STAFF RECOMMENDATION

945 S Douglas Avenue, Unit #1

February 17, 2021

Application: New Construction – Infill/Part II SP

Figure 7. Roof plan

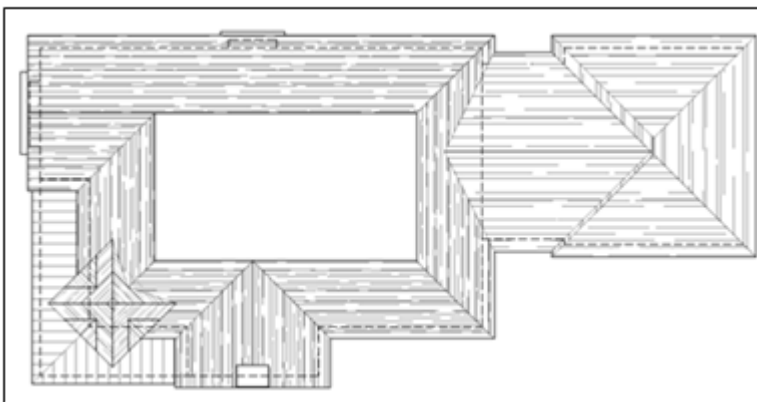
Roof Shape: The project uses a traditional front and side gable with a 12 /12 slope, which is appropriate. While the form appears to be an actual gable, the top of the roof is flat (Figure 7). This form has historic precedence and can be found throughout Nashville and within this overlay as well.

The design includes a turret feature on the front right corner. The turret itself has a complicated eave design inconsistent with the context. Turrets are not a common feature of the district or of the development era of this district. Staff finds that the turret is inappropriate for its high-style design.

With the removal of the turret, staff finds that the proposal meets section III.E for roof shape.

Figure 9. Massing study from Part I SP application

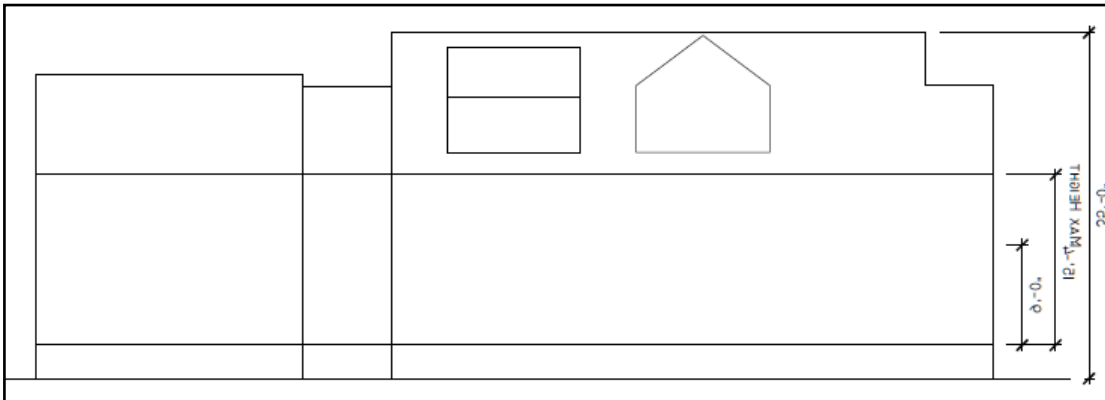
(Please note: Staff normally measures eave and ridge heights from grade. For the part I SP, the applicant submitted massing drawings with eaves measured from foundation height and ridge heights measured from grade, so staff analyzed it this way at the time. (Figure 9) Staff specifically clarified during the December 2018 hearing that the eave height recommendations were as measured from foundation height in this case, rather than from grade.)

Outbuildings: As per the approved SP, all nineteen (19) of the houses in this project will include an attached garage accessed off of the rear private drive. The massing studies from the part I SP application show the attached garages for the thirty-five foot (35') tall one-and-a-half story units #1-#7 as subservient in height with a ridge height of approximately twenty-seven feet (27') from grade and an eave of fifteen feet, four inches (15'4") from foundation. (Figure 9) The Commission approved Unit #1 to have a two-story form, something not proposed in the SP application. The ridge height was limited to thirty-five feet (35') and the eave to nineteen feet, eight inches (19'8"). No specific mention was made of adjustments to the garage massing.

The proposed attached garage has a ridge height of about twenty-seven feet (27') from grade and an eave of about nineteen feet (19'). Staff finds that matching the eave height to the house, while keeping the ridge and connector lower and subservient, is consistent with the SP approval.

Staff finds that the proposed attached garage is consistent with the massing and site plan of the approved SP.
